**Subject: Beaver Valley Power Station, Unit No. 2
Docket No. 50-412, License No. NPF-73
License Amendment Request No. 183
Revised Steam Generator Inspection Scope**

Beaver Valley Power Station, Unit No. 2 License Amendment Request No. 2A-183

Subject: Application for Amendment of Technical Specification 3/4.4.5 to revise the Steam Generator Inspection Scope.

Sketch of F* Distance in BVPS-2 Tubesheet

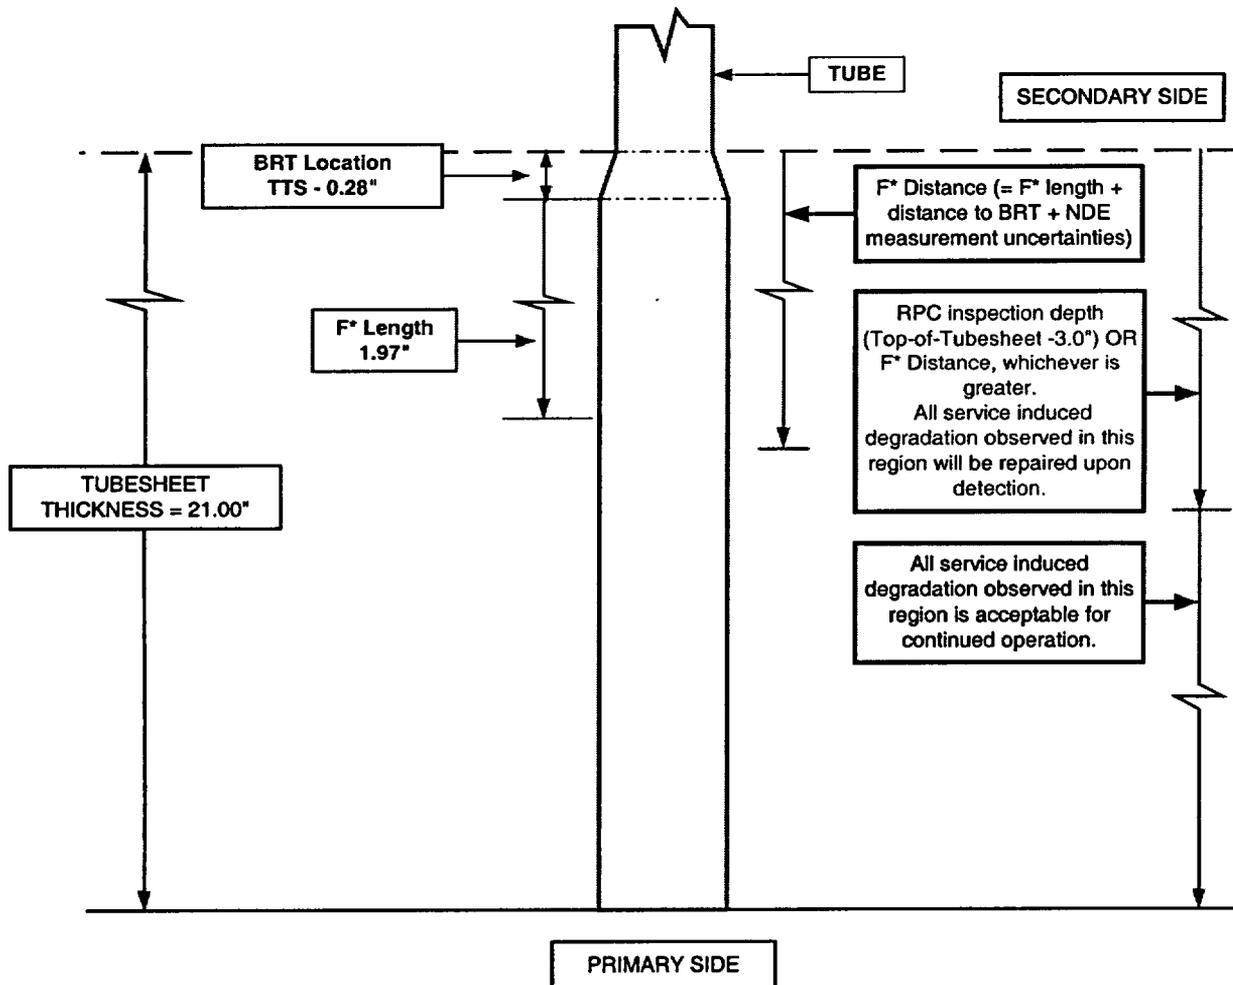
A tube plugging criterion (referred to as F*) has been developed by Westinghouse Electric Company LLC (Westinghouse) to permit tubes with observed and/or postulated degradation in the mechanical roll tubesheet expansions below the F* distance to remain in service. The F* analysis defines an undegraded F* length that assures adequate strength is available to resist the axial pullout loads experienced within the tubesheet and ensure leakage integrity. This proposed change would define the Technical

Specification SG tube inspection scope to exclude the length of tubing below the F* length on the hot leg side but is not requesting an alternate repair criterion.

BRT - Bottom of the roll transition and is defined in References 1 and 2, Section 3.0, as a nominal 0.28 inches from the top of the tubesheet.

F* Length - The maximum length of tubing below the BRT which must be demonstrated to be non-degraded and is defined in References 1 and 2, Section 2.2.3, as 1.97 inches below the BRT.

F* distance - The distance from the top of the tubesheet to the bottom of the F* length including the distance to the BRT and NDE uncertainties. Uncertainties are defined in References 1 and 2, Section 2.5, as 0.25 inch.
